# DEVIATION REQUEST AND DECISION FORM

Project Name: Sterling Ranch Phase 2 Preliminary Plan

PCD File No. SP 19-006

A deviation from the standards of or in Section ECM Standard Drawing SD 2 77 Urban Local Knuckle SDT Length of the Engineering Criteria Manual (ECM) is requested.

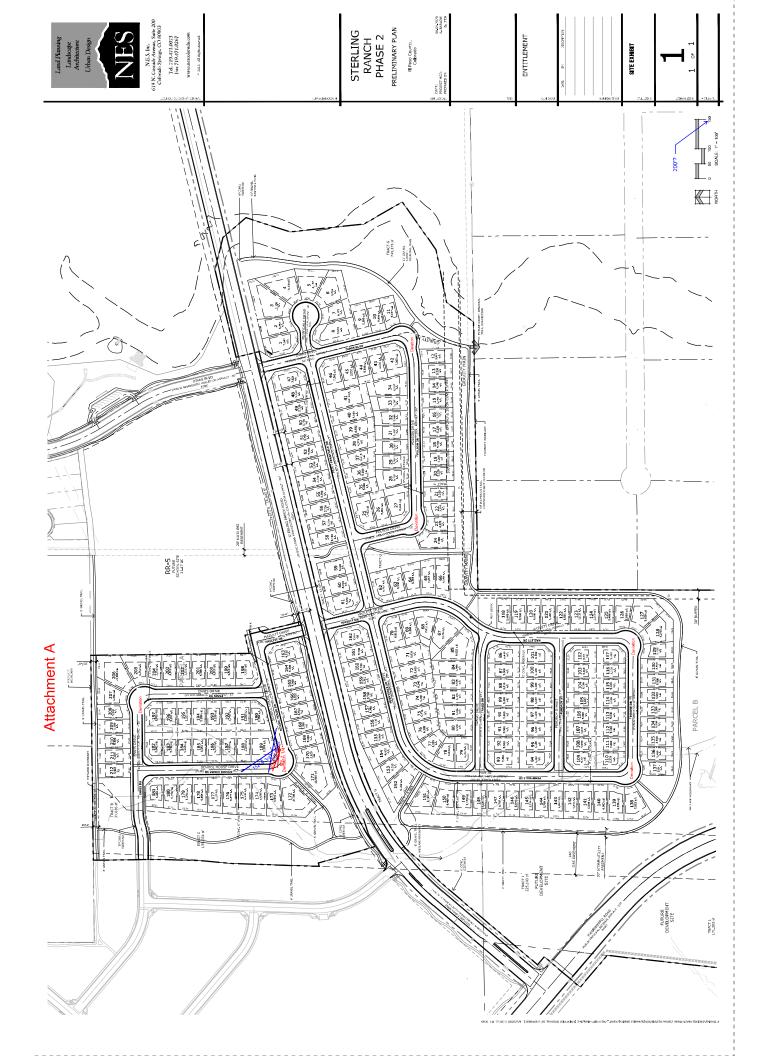
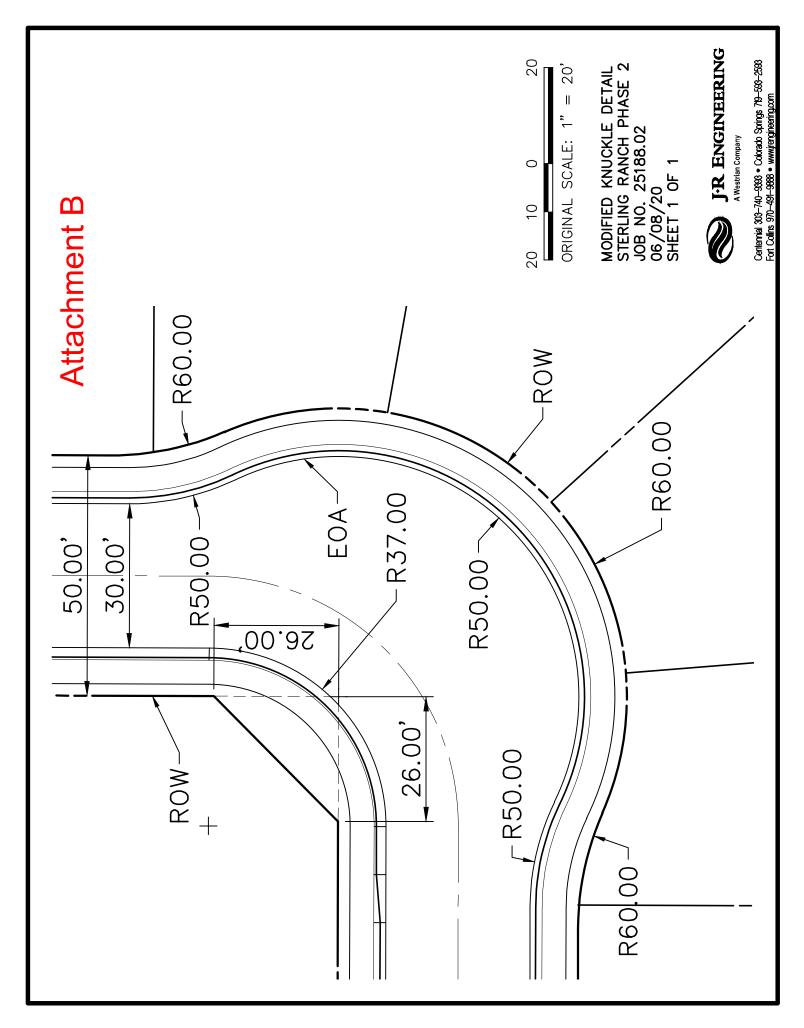
Provide actual sight distance lines and dimensions on the roads and lots affected. Is additional signage required?

For 15 MPH:

$R=V^2/(15x(0.01E+F)) E=-2, F=0.32$

R=225/(15x(0.3)) = 50'

For R=43', V ~ 14 MPH

For 15 MPH, stopping distance ~ 75-80'?

> Added sight distance lines on attachment, we do not believe signage is required.

## URBAN LOCAL KNUCKLE DETAILS

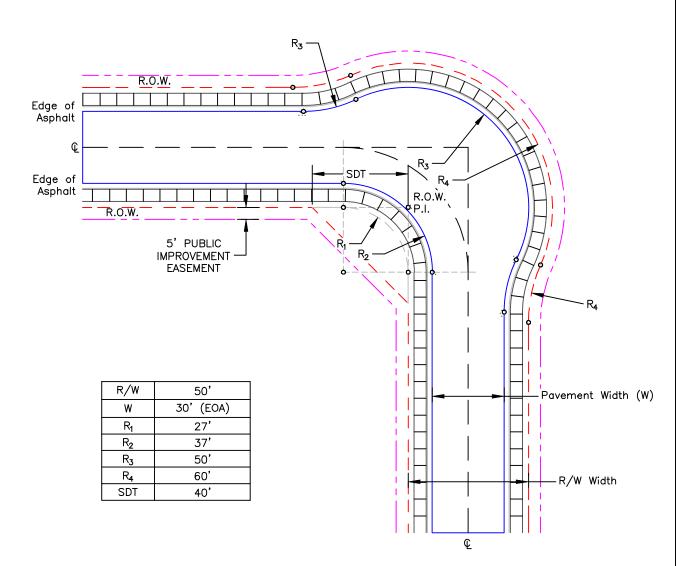
The proposed alternative is to reduce the SDT dimension to a minimum of 26 feet vs. the 40 feet dimension listed on SD 2 77 Urban Local Knuckle. In the locations where the deviation is requested, the traffic is minimal and the design assumption of 25 miles per hour as listed in the SD\_2\_77 drawing is not likely. All other aspects of SD-2\_77 (R/W, W, R1-R4) eare adhered to in the proposed land plan.
